## ASSESSMENT REPORT

### Section 75W Modification Fern Bay Seaside Village, Fern Bay MP 06\_0250 MOD 9

**Figure 3 – Location of proposed modifications (base image source: Nearmap)**

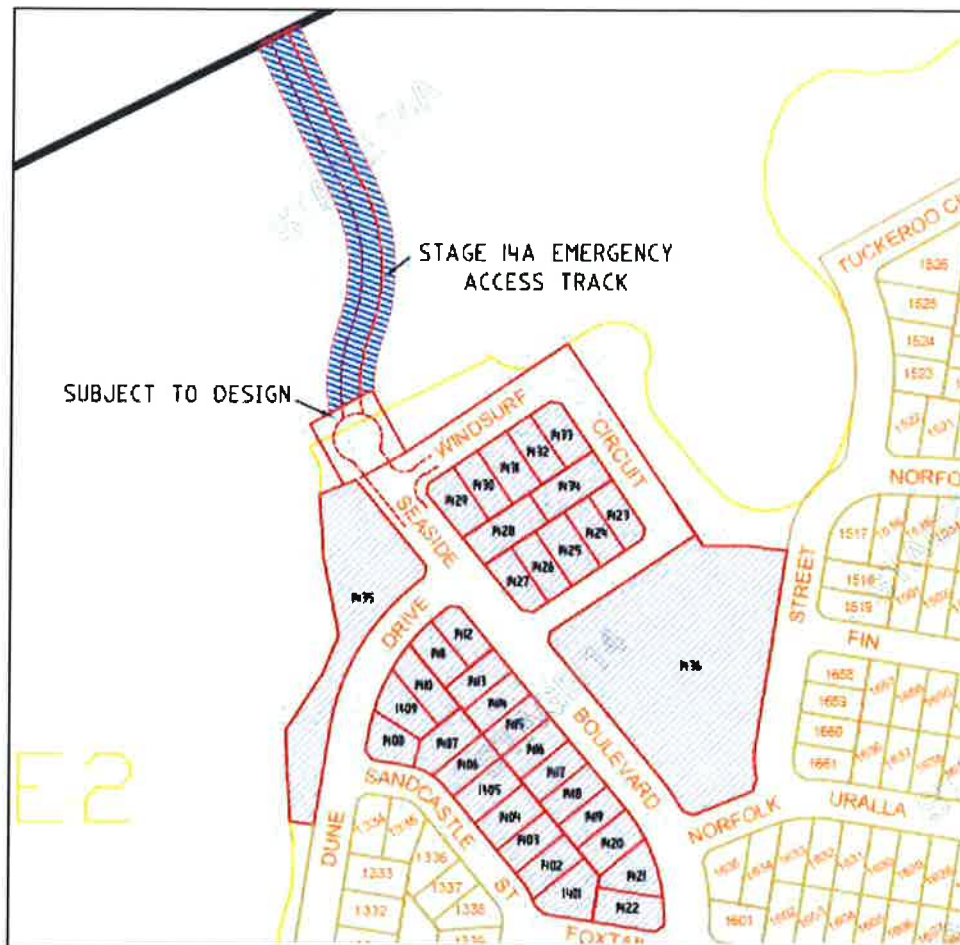
The location of the proposed modifications within the estate are shown in **Figure 3** and a detailed description of the proposed modification is provided below.

**Figure 6** – Proposed subdivision layout stages 18 – 20 (source: application documents)

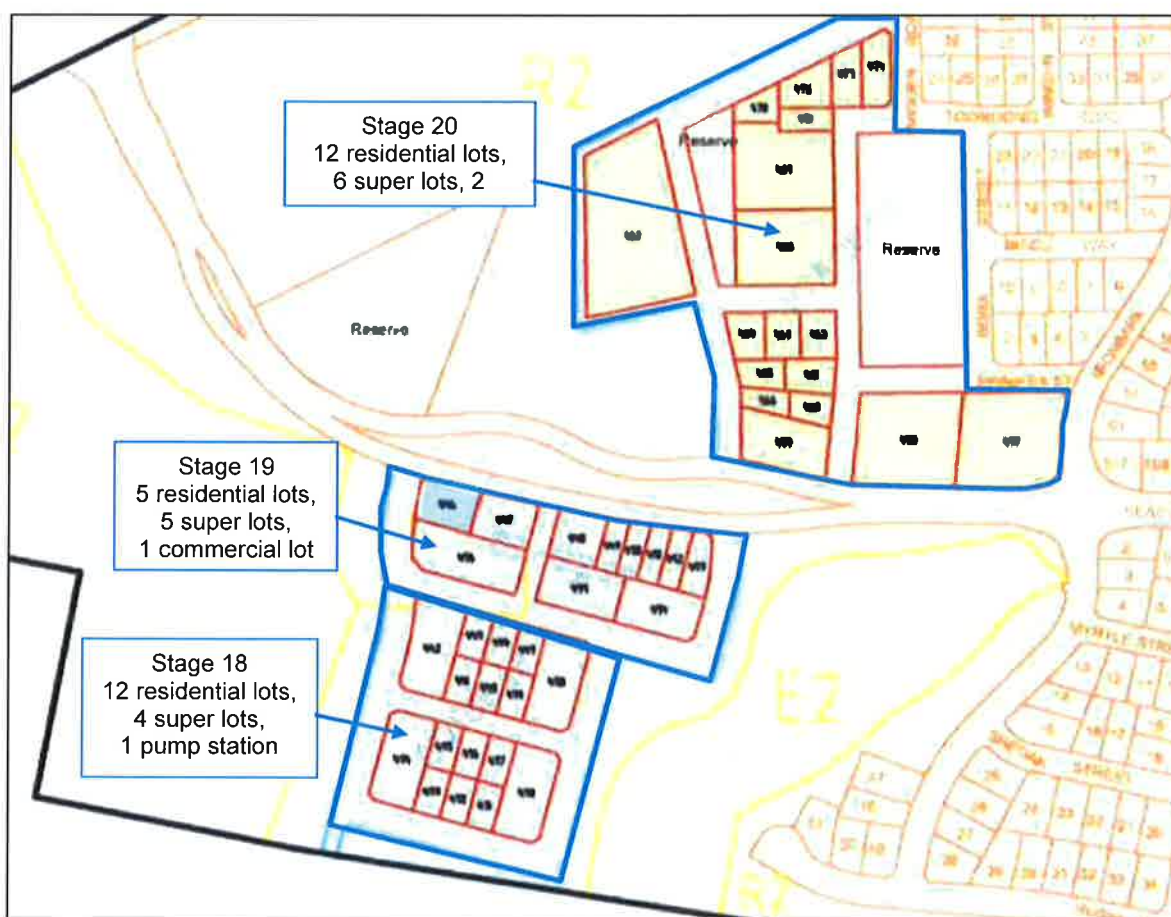
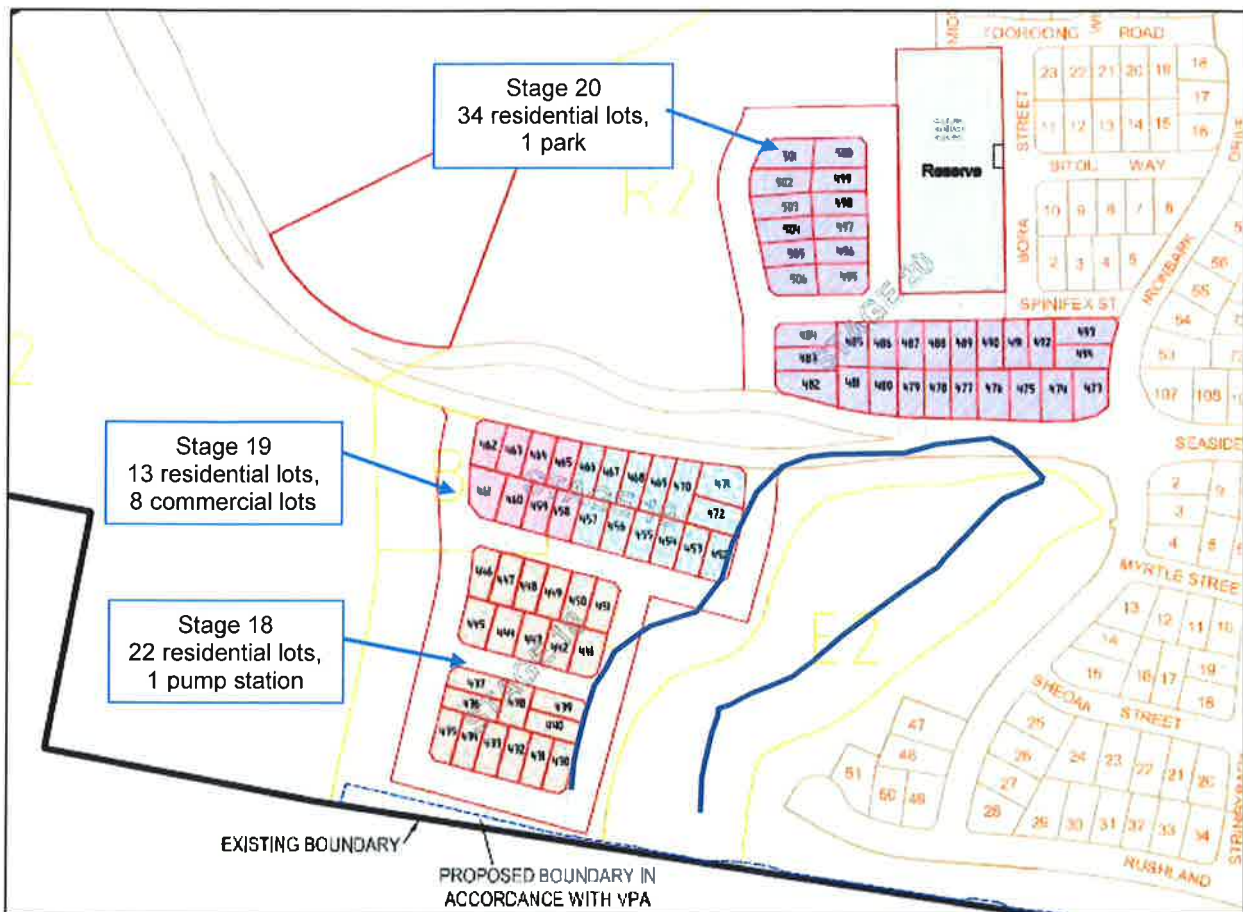
Key changes to the subdivision of Stages 18 to 20 are shown in **Figures 5** and **6** and include:

- deletion of 15 super lots
- creation of an additional 40 residential lots
- creation of an additional seven commercial lots
- reduced development footprint in Stage 20
- changes to road layouts
- changes to bulk associated earthworks
- deletion of vehicular access from Stage 18 to the adjoining WCL.

Council and OEH (including NPWS) raised concern about the potential ecological impacts associated with the revised subdivision layout of Stages 18 and 19, specifically the encroachment of roads and associated batters into the E2 Conservation Zone.

In response to these issues, the Proponent amended the plans to remove the encroachment of the roads into the E2 Conservation Zone (refer **Figure 9**). However, OEH noted the revised proposal still incorporates significant areas of bulk earthworks (and therefore vegetation removal) within the E2 Conservation Zone.

Given the potential ecological and biodiversity impacts associated with the clearing and excavation, the Department does not support the proposed change. Given the approved subdivision layout has a similar development footprint to the proposed layout, and did not require such extensive bulk earthworks, it is considered that the proposed layout should be provided without any earthworks encroaching on the E2 Conservation Zone. A condition is therefore recommended, requiring a revised bulk earthworks design which does not encroach on the E2

**Figure 9:** Extract from proposed bulk earthworks diagrams, with E2 conservation zone boundary outlined in orange dash (base image source: Proponents supplementary RtS)

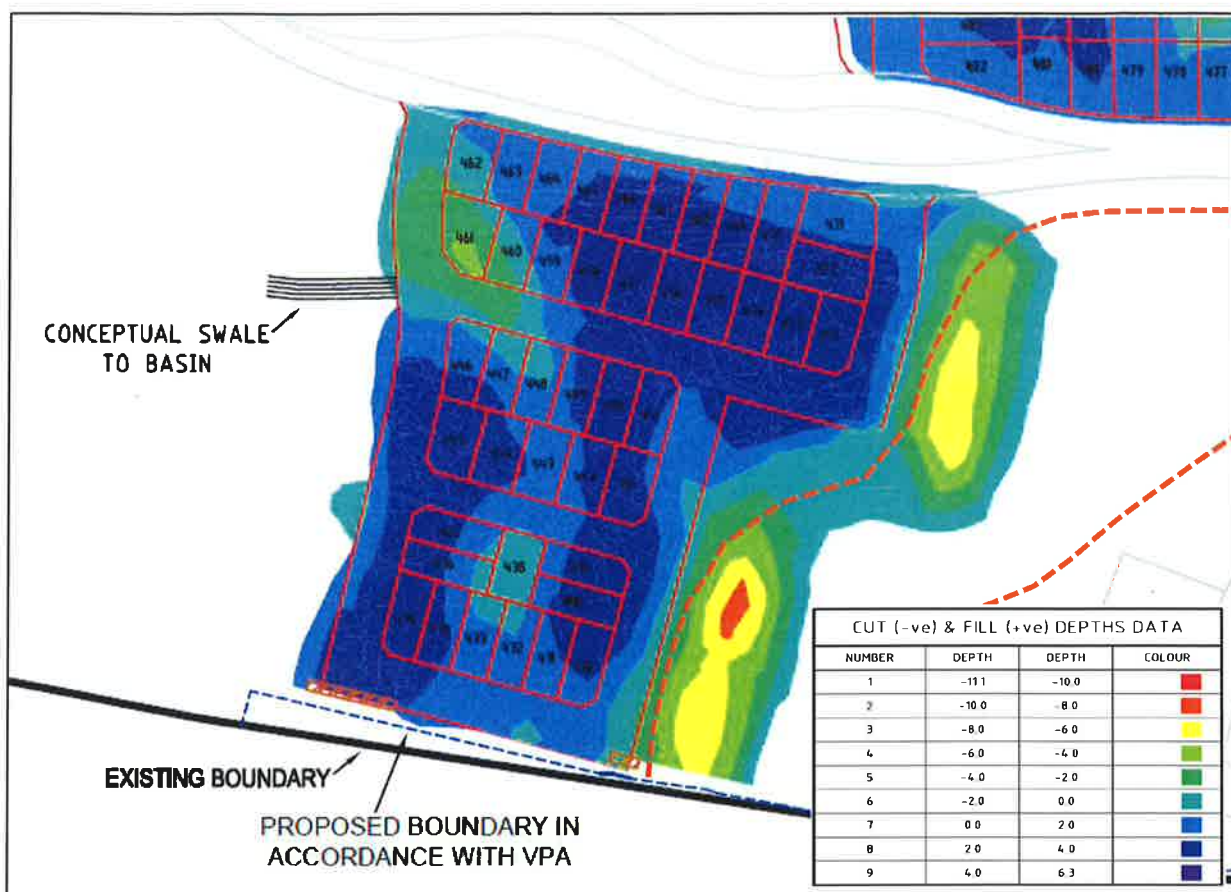
The Department notes the proposal incorporates significant areas of excavation within the E2 Conservation Zone, with excavation depths exceeding 8 metres (**Figure 9**). This is a significant variation from the approved design, which does not incorporate any bulk earthworks within or in close proximity to the E2 Conservation Zone (**Figure 8**). The Proponent has not provided any justification for the proposed change or any assessment of the biodiversity impacts of the proposed clearing and excavation.

Conservation Zone, to be approved prior to the issue of a Construction Certificate for Stages 18 or 19.
